Re: Letter of Intent - Resubmitted

20120410 - Pacific Cycle - Office Expansion

1 SITE PLAN
A101 SCALE: 1" = 30'-0"

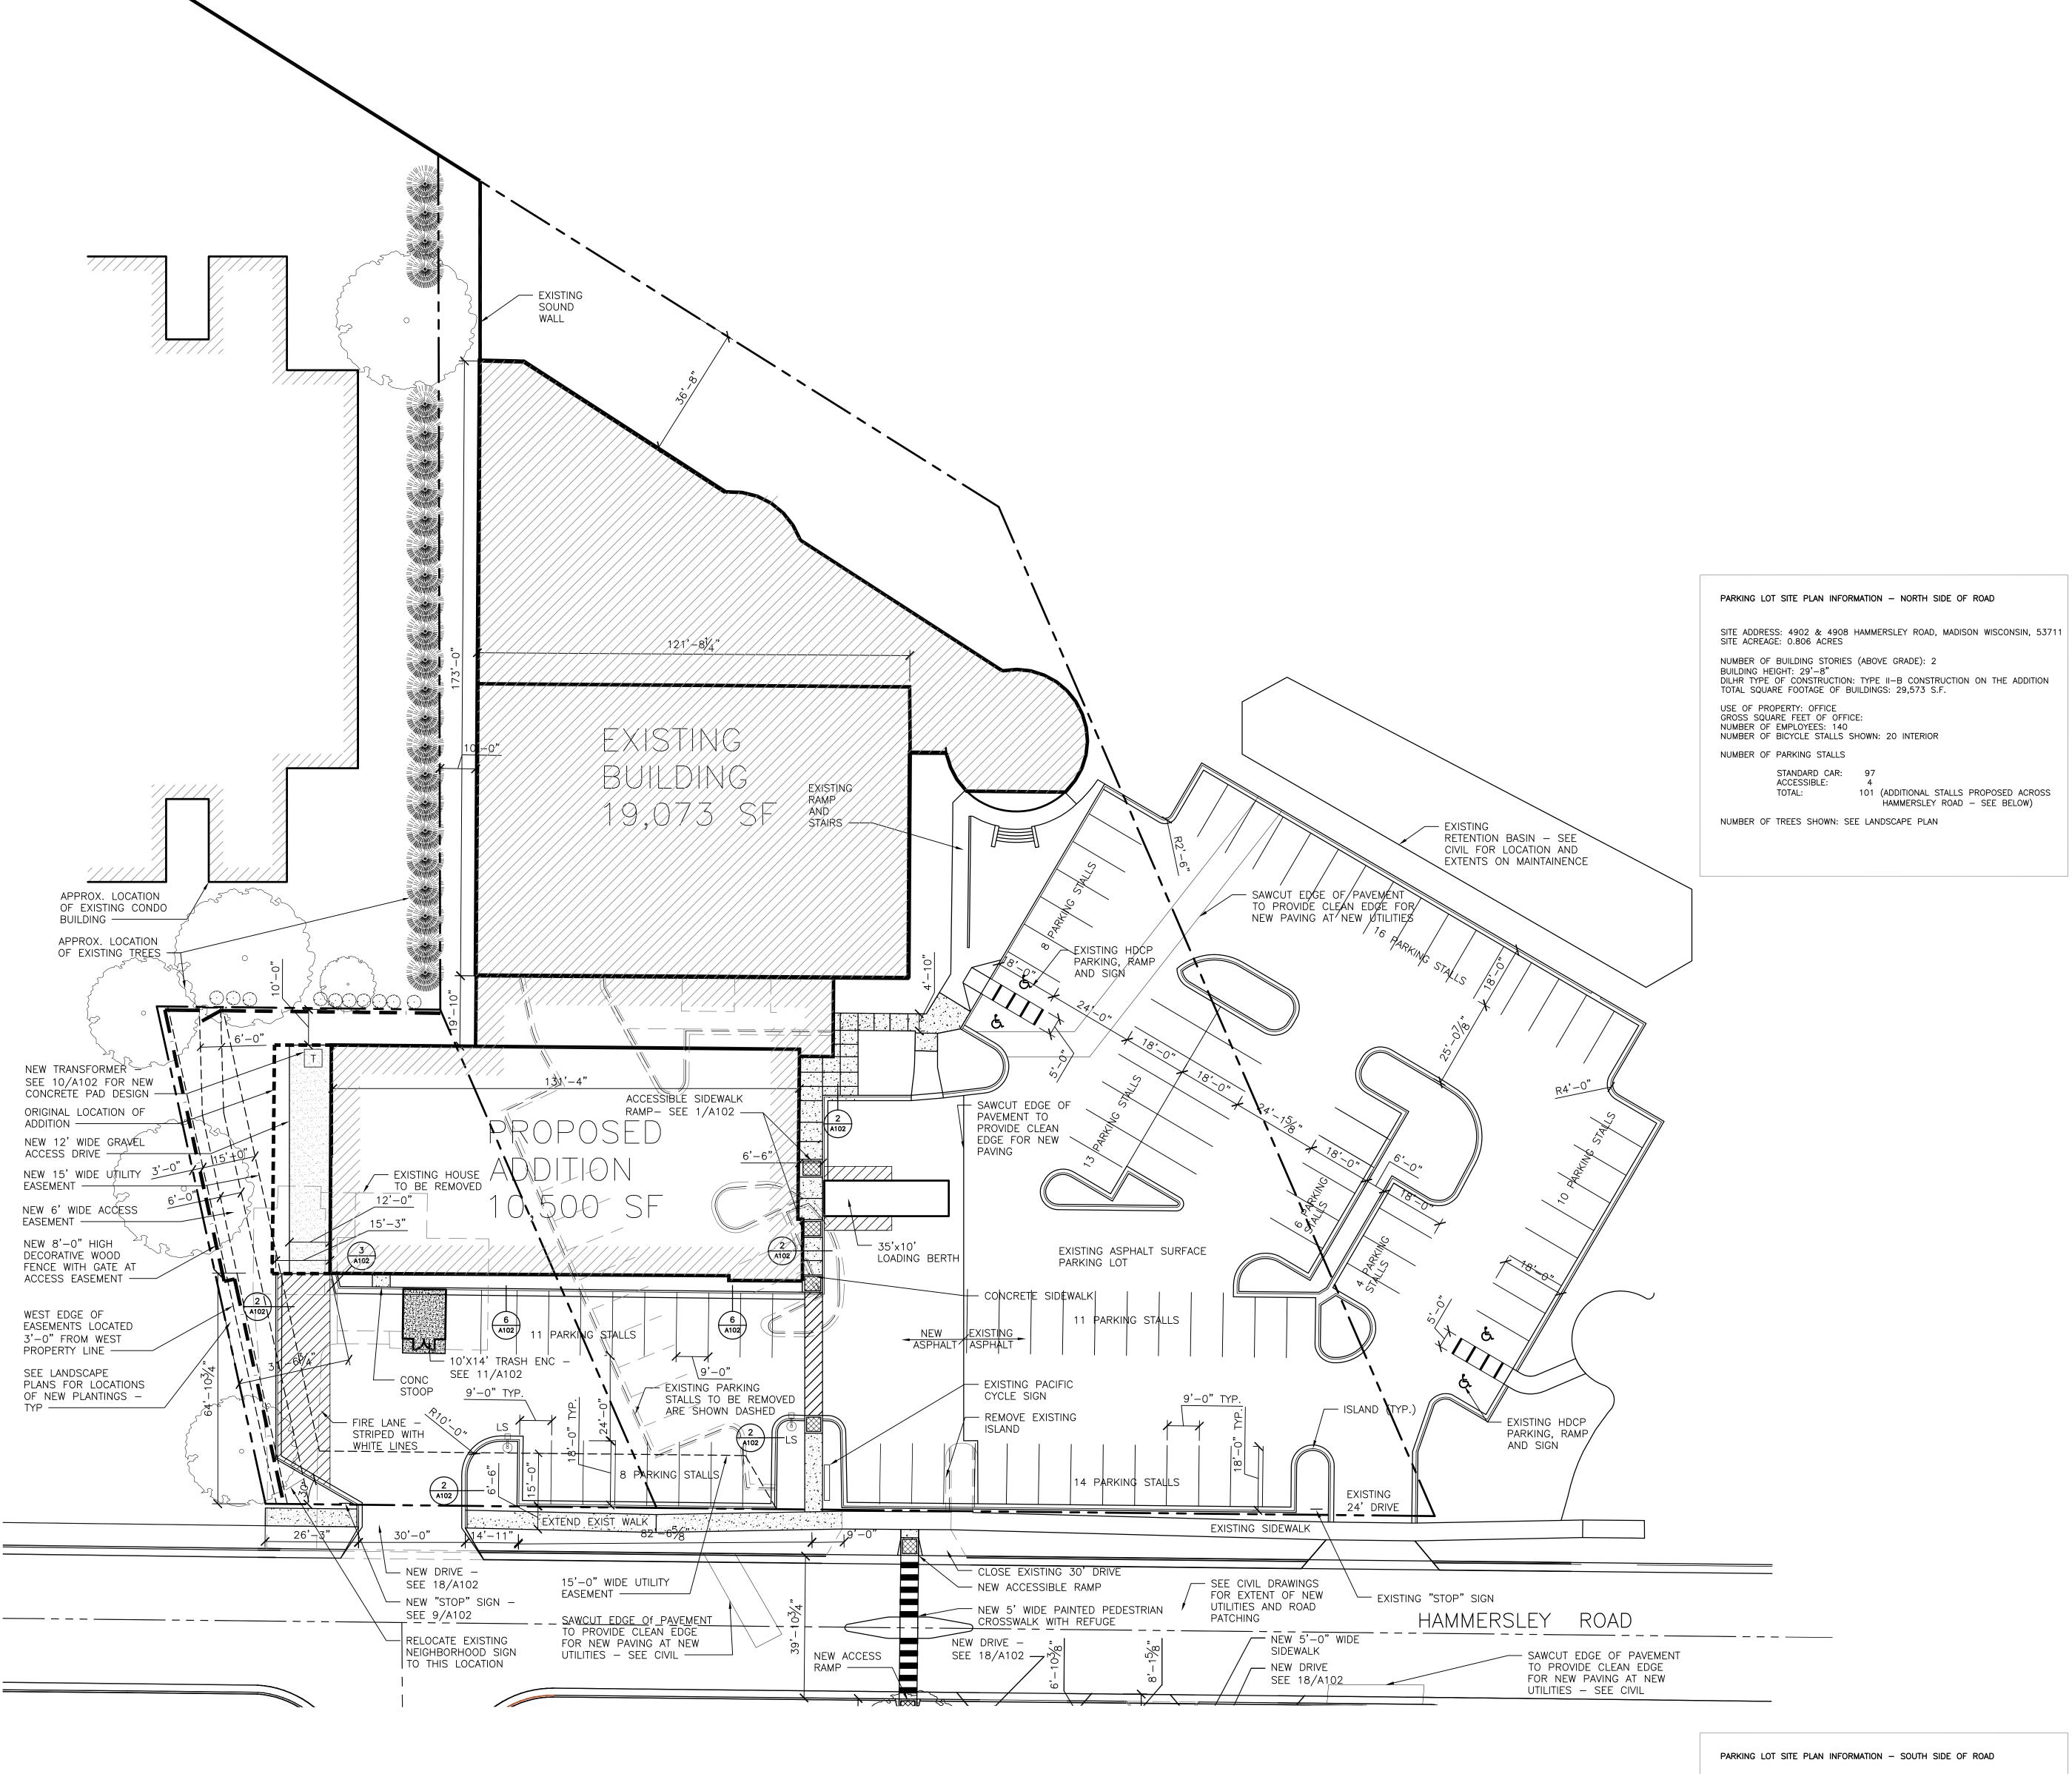
In response to staff, neighbor's and Commission concerns on the parking issues, we have updated the drawings to provide a decorative wood fence separating the proposed lot at 4817 Hammersley from the adjacent residential neighbors. Landscaping will be provided outside of the fence to soften the edge. The height of the fence will be set at the highest allowable by Zoning. Additionally, a decorative wood fence will be provided on the west and north edges of the 4908 property to screen the parking lot and building from the adjacent residential lots. This too will have landscaping provided to aid in screening and softening the edge.

We have worked to locate the curbs and gutters to allow for retention of as many existing trees as possible on the 4817 Hammersley site. Stormwater management designs have been revised such that 2 large existing trees located in the northwest corner of the site should be able to be preserved. These trees have been identified on the revised site plan along with approximate locations of existing trees to remain on the adjacent neighbor's lots.

Another revision shows a more clearly defined pedestrian path that leads from the proposed 4817 parking lot, across Hammersley Rd, through the Pacific parking lot to the new employee entrance. We will work with City staff to refine the location of a refuge area on Hammersley Rd prior to construction.

Due to the shifting of the addition (more detail is outlined below) and the extension of the pedestrian path, **8 stalls were removed from the original request**. This along with other minor tweaks to the plan has netted 1,600 sf of surface that was originally identified to be paved; now being green space located along the west and north edges of the 4908 lot.

1 SITE PLAN - 4902/4908 A101 SCALE: 1" = 20'-0"

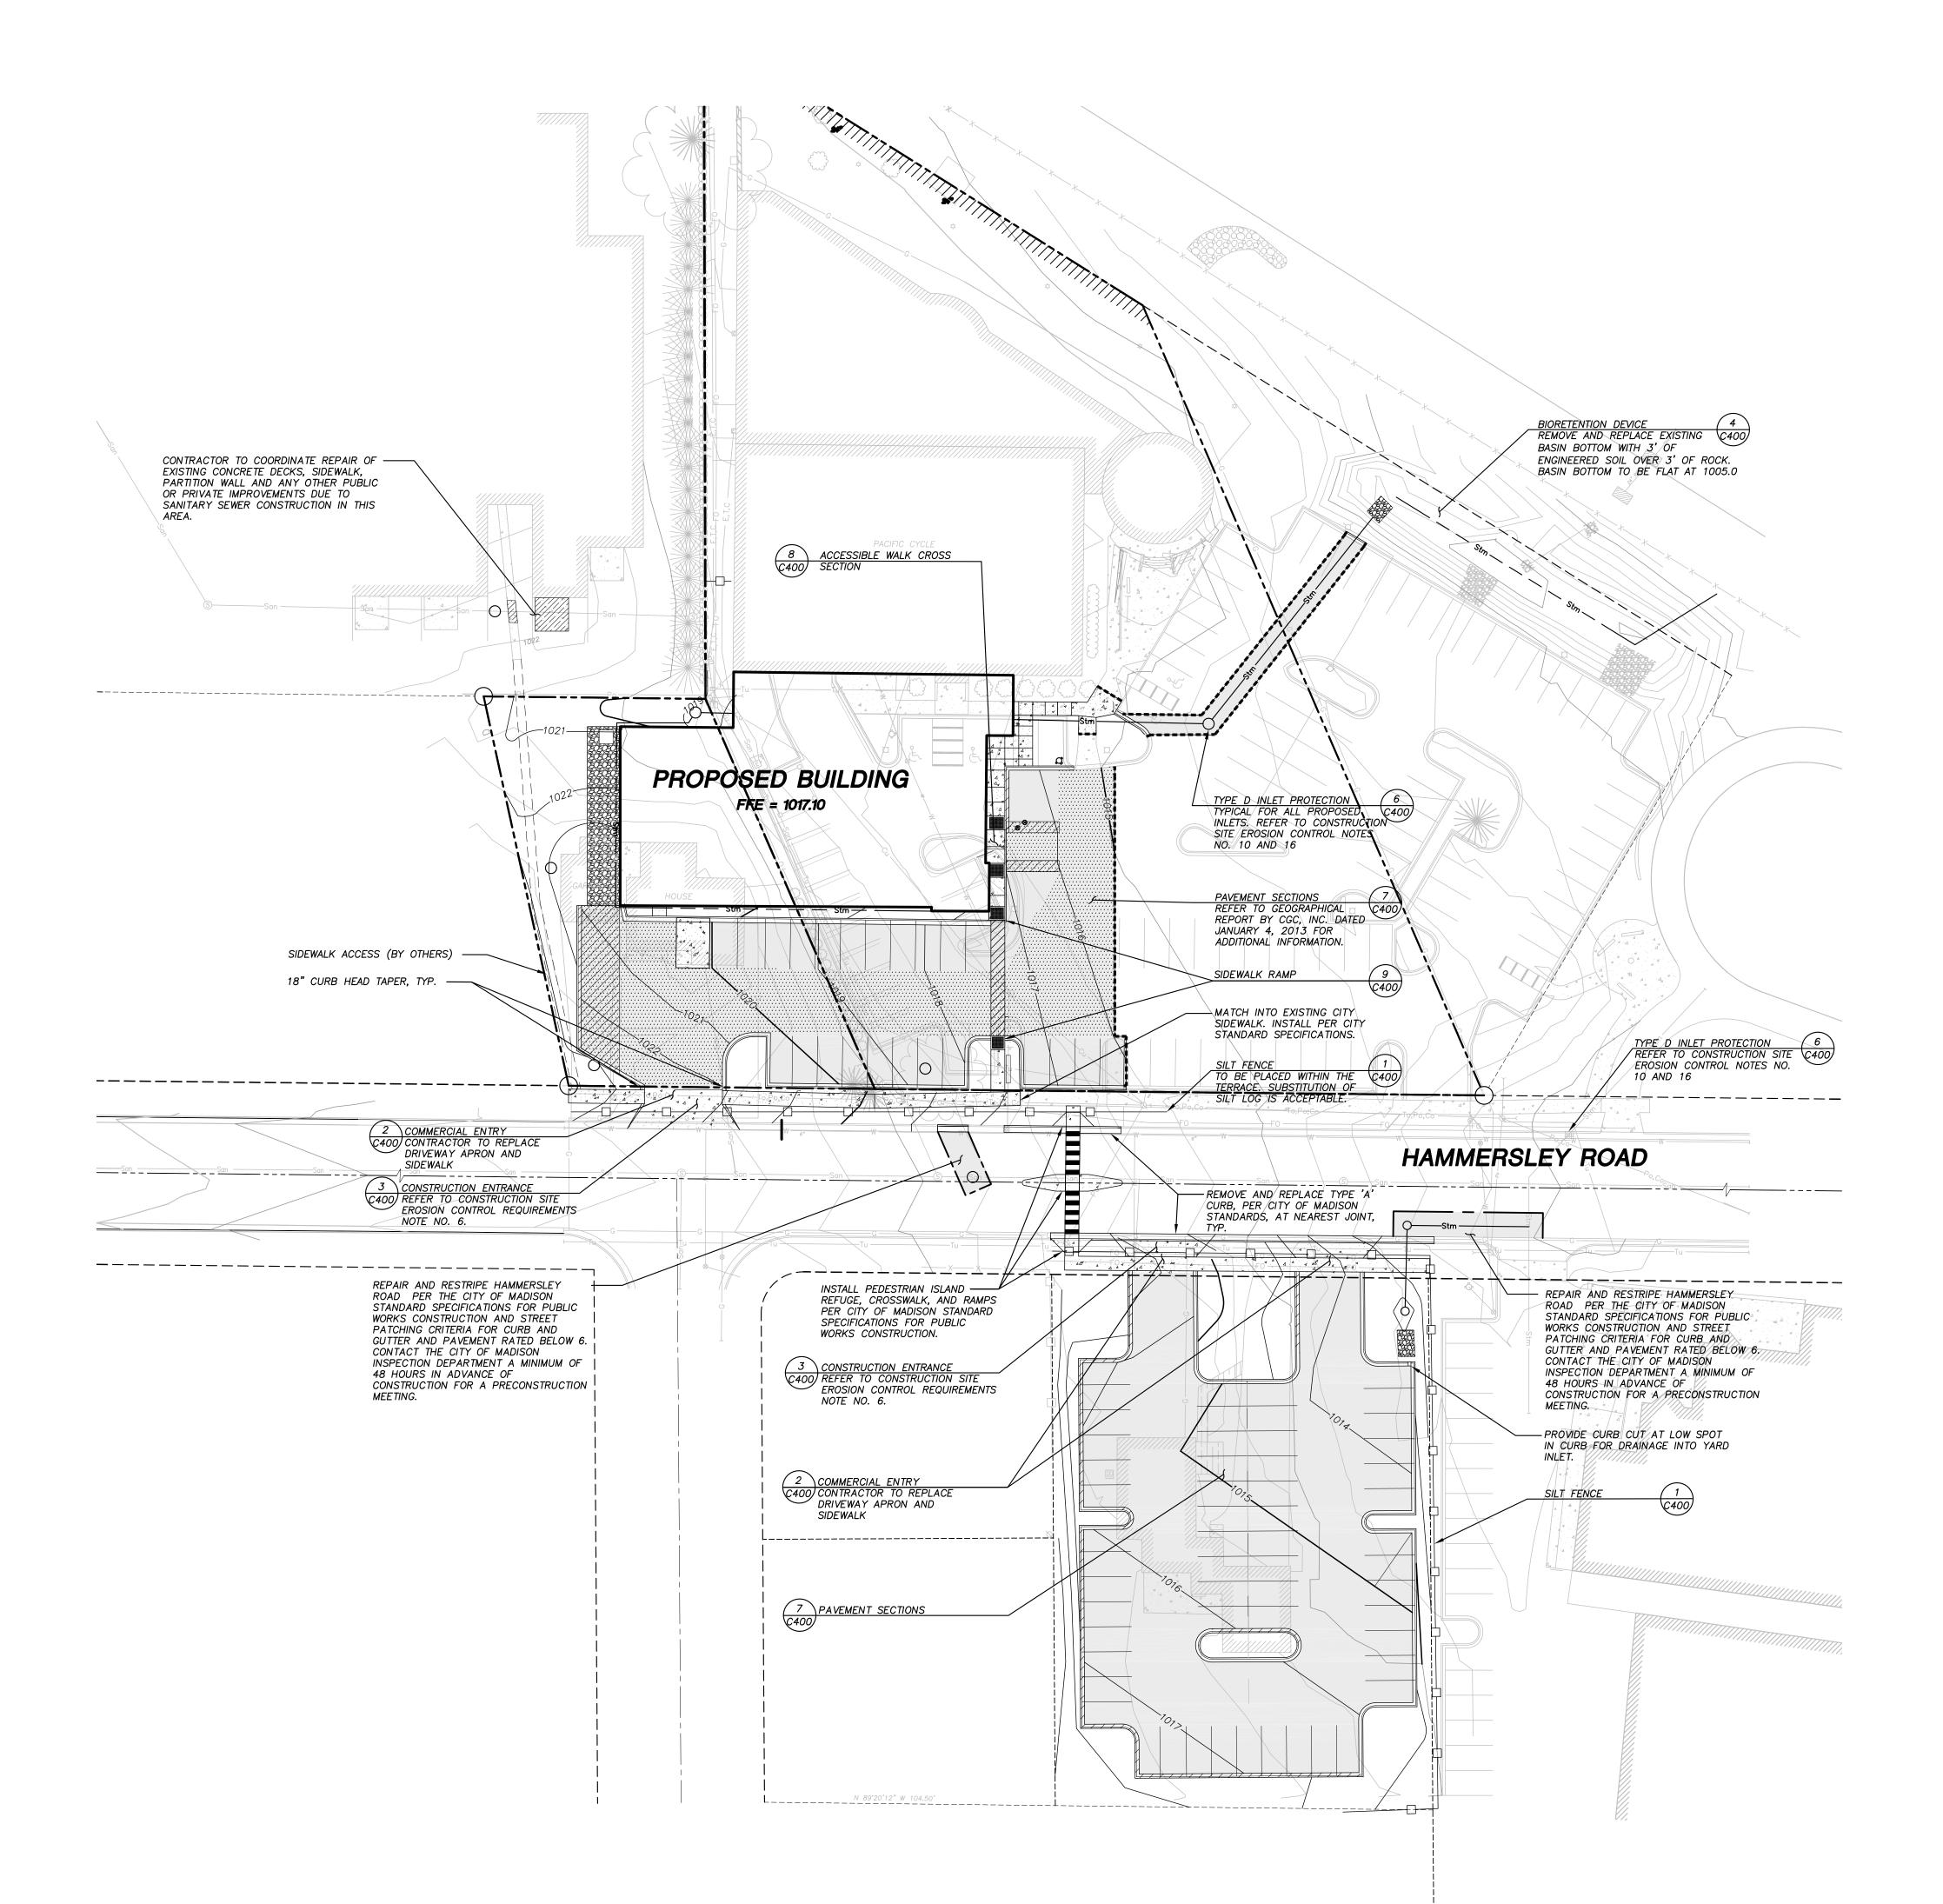
In response to the concerns of the neighbors to the northwest and Commission members, we have revised our building and site plan to **relocate the proposed addition 16' to the east**. We have located an outline of the existing condominium building to show their relationship to the proposed addition. In addition to the existing vegetation on the condominium owner's property additional plantings will be made to provide screening of the new addition. Building elevations have also been provided to show that the proposed addition will be skinned in materials of the same palette on all elevations; it will not be a bear concrete block wall. The new location will allow us to **recess the building structure** into the current slope lowering the visible height by as much as 4 feet.

The land owner has proposed a resolution to the 4 foot access easement previously granted to the condominiums north and west of the Property. The proposed solution includes an increased 6'-0" wide access easement being provided along the western edge of the 4908 lot and over the top of the utility easement. Details are still being discussed at the time of this writing.

While shifting the building 16 feet east we have also relocated the truck berth to the east side of the building which will provide an acoustic separation from the delivery vans and the neighbors to the west and north of the site.
